# UNITED STATES PATENT AND TRADEMARK OFFICE

APPLICATION NO.	FILING DATE	FIRST NAMED INVENTOR	ATTORNEY DOCKET NO.	CONFIRMATION NO.
09/982,503	10/19/2001	Stephen W. Boyd	HRT-0281	8002
27777	7590	06/20/2005	EXAMINER	
PHILIP S. JOHNSON JOHNSON & JOHNSON ONE JOHNSON & JOHNSON PLAZA NEW BRUNSWICK, NJ 08933-7003			ISABELLA, DAVID J	
			ART UNIT	PAPER NUMBER
			3738

# Office Action Summary

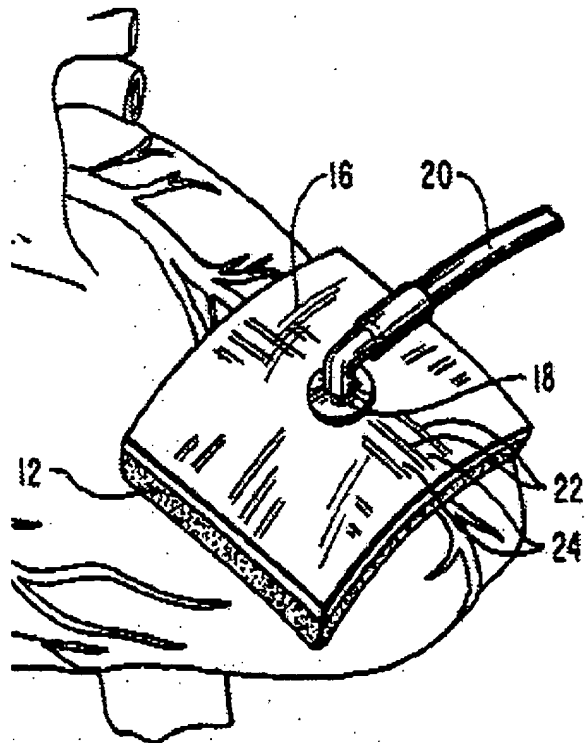
Todd et al discloses a surgical retraction device comprising: a shaft (20) having a proximal end and a distal end; a contact surface (16) adjacent said distal end for manipulating or retracting living tissue within a body cavity; and a means for applying a vacuum at said contact surface.

Claim 108, see friction increasing surface 12 or elements 22.

Claim 121, see curved surface of the contact surface near the distal end of the shaft 20 as illustrated in the figure above.

Claims 122-125, see element 12.

Claim 128, see lumen 20.

Claim 129, see tubing 20.

Claims 182 and 183, see porous pad 12 which provides a plurality of holes along the contact surface as broadly claimed. The claim, as worded, does not require the holes be formed in the contact surface. Note the porous pad communicates with the passage 18 formed in the contact surface.

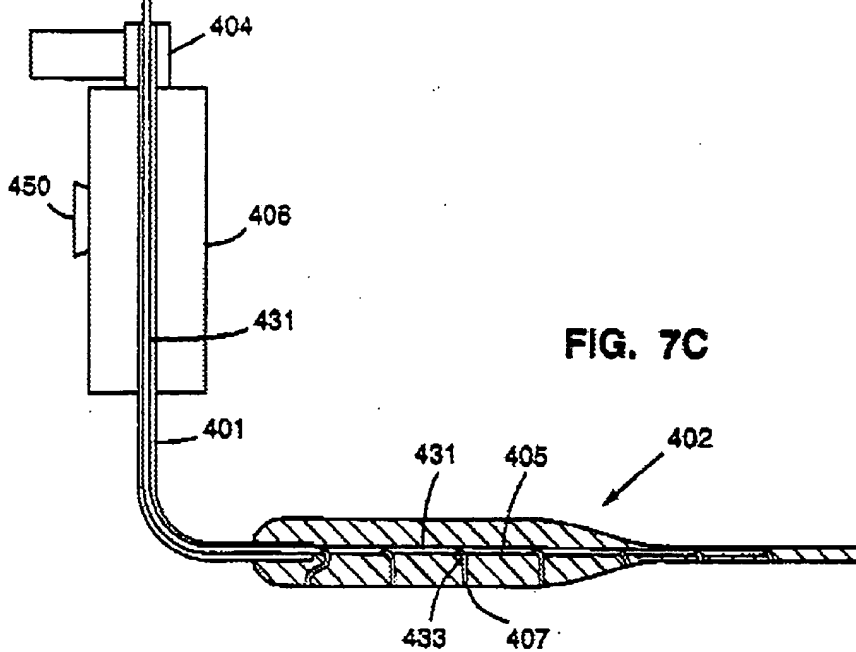
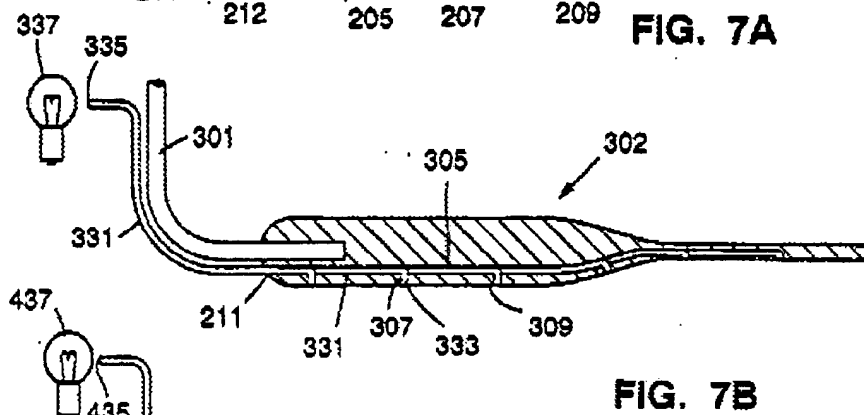
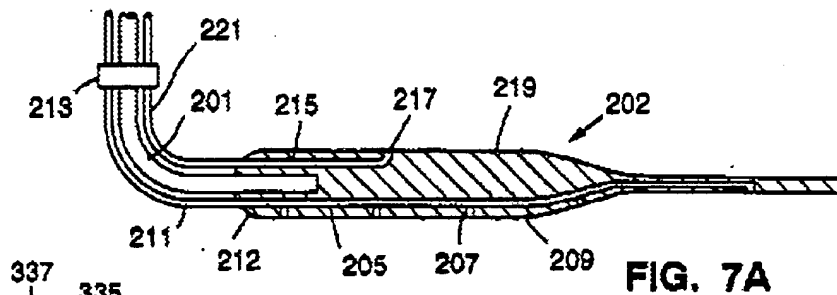
Kramer et al discloses a surgical retraction device comprising: a shaft (201,301,401) having a proximal end and a distal end; a contact surface (202,302,402) adjacent said distal end

for manipulating or retracting living tissue within a body cavity; and a means for applying a vacuum at said contact surface.

Claims 182 and 183, see apertures formed in the body of elements 202,302 and 402 each body providing a plurality of holes along the contact.

Claim 121, see curved portion of the shaft proximal to the contact surface near the distal end as illustrated in the figures above.
